Pacific Accessory Corporation

Radio Replacement Interface for Select Mazda Vehicles with Bose Sound Systems

Tech Brief

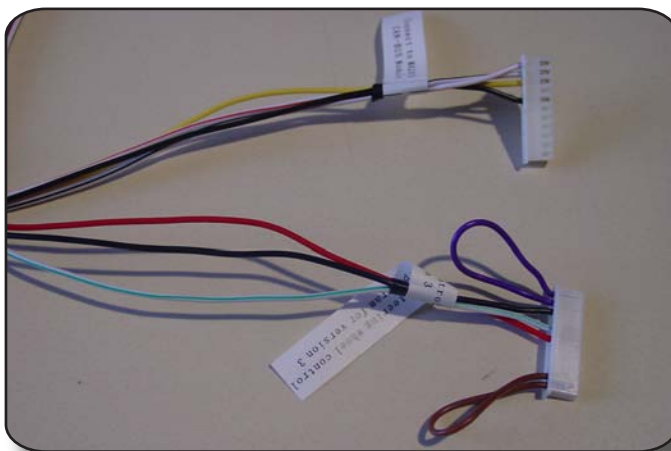
There may be an occasion where a wire is missing in the harness. This wire being missing will cause the amplifier in the vehicle to not turn on. This can be easily fixed, in field, by the installer. The first picture below is of an affected harness. There should be a blue/white wire connecting pin 1 of the top connector to the red wire on the second connector.

Remove the brown loop from the connector B. This can be done using a pick tool and depressing the locking tab on the exposed pin in the connector. Once the brown loop has been removed from connector B, one side of the brown wire will need to be inserted into the #1 pin position on connector A (see pic below). The other side of the brown wire will need to be connected to the red wire on connector B.
